WATTS BAR NUCLEAR PLANT (WBN) - ADDITIONAL DIESEL GENERATOR (TAC NO. 63606)

This letter provides TVA's response to NRC's request for additional information (RAI) dated July 28, 1986, concerning WBN's emergency diesel generator systems, the additional diesel generator system, and the buildings associated with these systems. The RAI included 18 questions for TVA to answer. Furthermore, one of these questions (Question 040.129) identified another 50 previously answered questions that might require updated responses to address any differences or unique aspects of the additional diesel generator and its building in comparison to the other diesel generators and their buildings. The RAI requested a response in a timeframe consistent with WBN's fuel load date.

REQUEST FOR ADDITIONAL INFORMATION
WATTS BAR NUCLEAR PLANT, UNITS 1 AND 2
DOCKET NUMBERS 50-390 AND 50-391

SCHEMATIC DIAGRAM LUBE OIL
 SYSTEM
 DRAWING NO. 6036F03001
 FIGURE NO. Q40.128-2

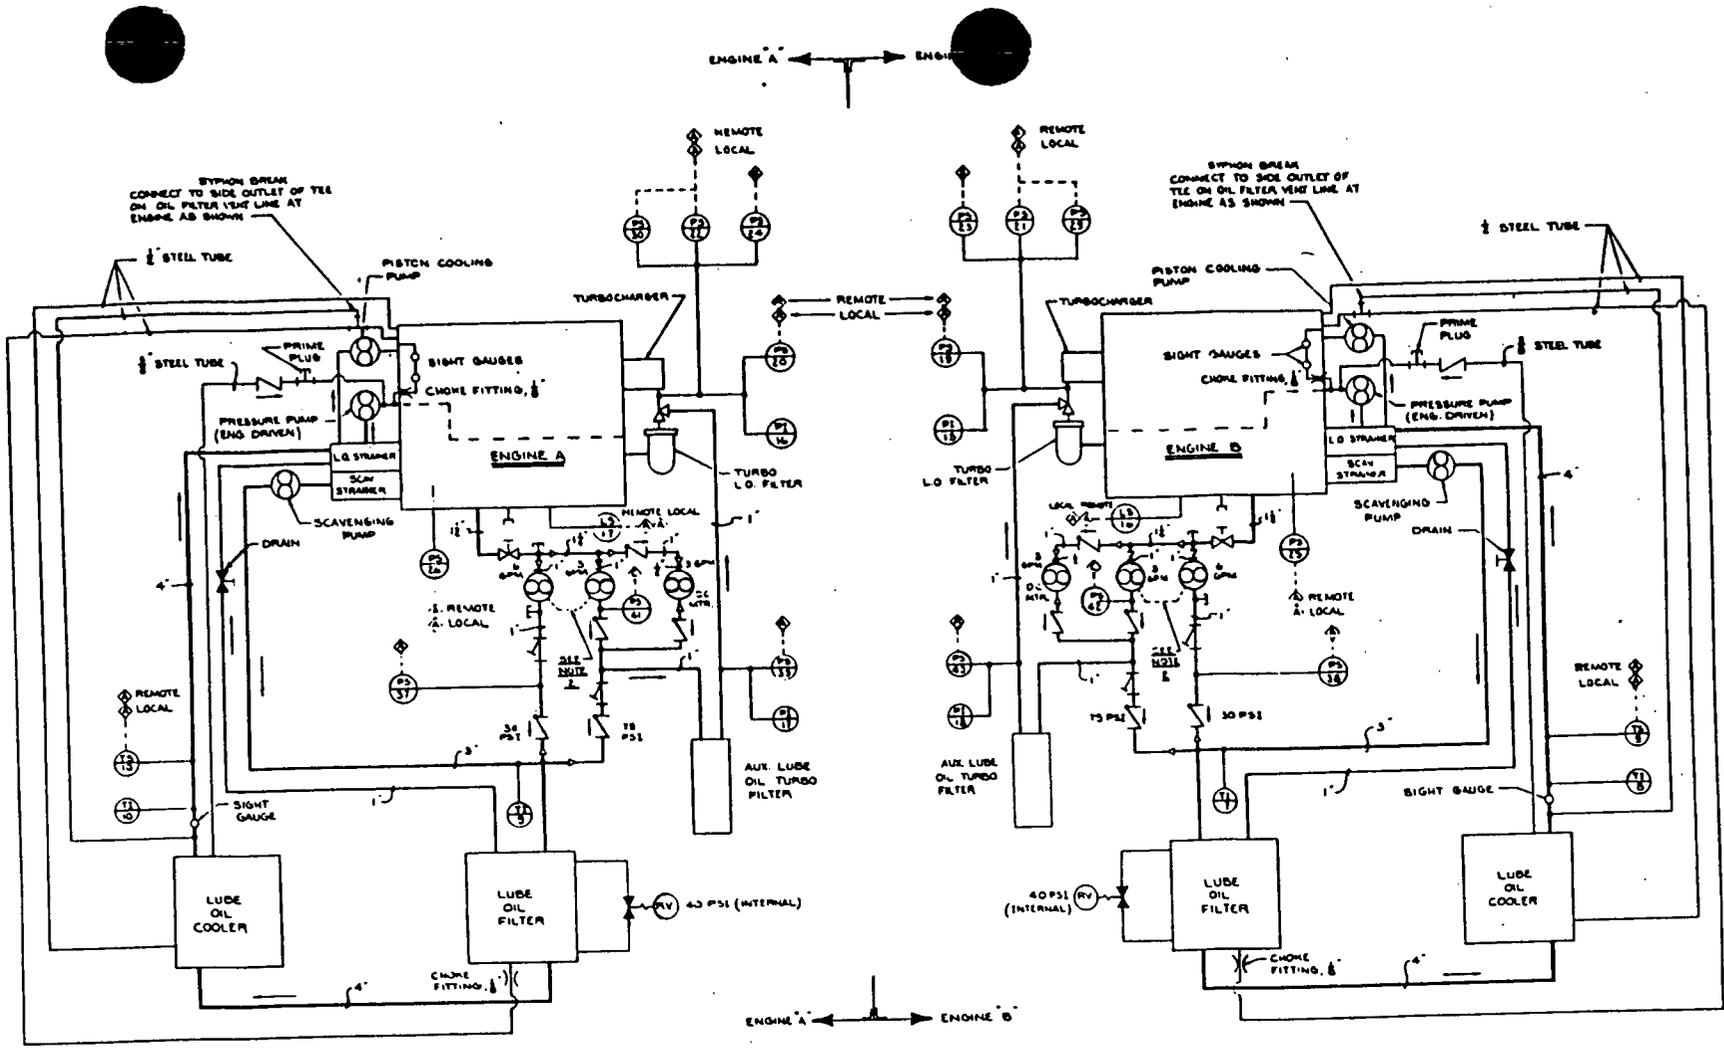
1. Diagrams and drawings in the maintenance manuals show the main bearing pump lube oil system providing lubrication to the camshaft rocker arm assembly and other upper engine wearing parts except the cylinders and pistons. The M.I. 9644 mods provide a continuous 'Trickle' flow to the main bearing pump system. Indicate whether this trickle flow is sufficient to provide lubrication to the upper engine parts and the means used to prevent the oil from lubricating these parts during standby conditions. Also, provide a description with the appropriate diagrams of the lubrication system in the engine.
2. Several applicants have proposed to provide manual or automatic intermittent prelubrication for the entire engine. This lubrication would

be for a few minute (less than 10 minutes) a day or a week. Does TVA propose to provide this prelubrication? If not, does TVA or the manufacturers have any problems with this proposal in light of the manufacturer's prelube recommendation? If so, discuss the objections.

3. (a) If TVA proposes to modify the engines using that proposed in EMD-GM's M.I. 9644, show how this modification will not cause undue wear to the failure to start over the lifetime of the plant for both emergency and periodic test starts. In your response, consider the NRC's concerns on dry starting and the manufacturer's concern on undue wear on high speed emergency engine starting.

(b) If TVA does not propose to provide the modifications of 3(a), state how TVA will prevent undue wear to the upper engine parts, degradation of engine reliability, or diesel engine failure to start considering the conditions stated in 3(a).

The engine lubricating oil system is a combination of four (4) separate systems for installation with turbocharged engines. For a detailed schematic of the lube oil system supplied on these engines, refer FSAR Figure 40.128-2.

B.2 The flow provided by the soakback system constitutes a constant prelubrication of the engine and therefore we propose no intermittent prelubrication. Our supplier, Power System - a Morrison-Knudsen Division, concurs with this proposal.

B.3 We are in the process of modifying the WBN engines per EMD-GM's M.I. 9644 and will have it completed prior to Unit 1 fuel loading. As previously stated, these modifications are designed to reduce lubricating oil system drain-down during standby. By continuously furnishing a small quantity of oil and thereby keeping the system full, an oil film would be maintained on the moving parts without causing leakage into the cylinder or into the exhaust system by introducing oil above the cylinders or due to excessive oil pressure during standby. Leakage into the cylinders could cause a hydraulic lock upon receipt of a start signal whereas leakage into the exhaust system could result in fires as outlined in NUREG/CR-0660, 'Enhancement on On-Site Emergency Diesel Generator Reliability.'

(Note: This lube oil modification has already been incorporated in the additional diesel generator at the factory prior to delivery.)
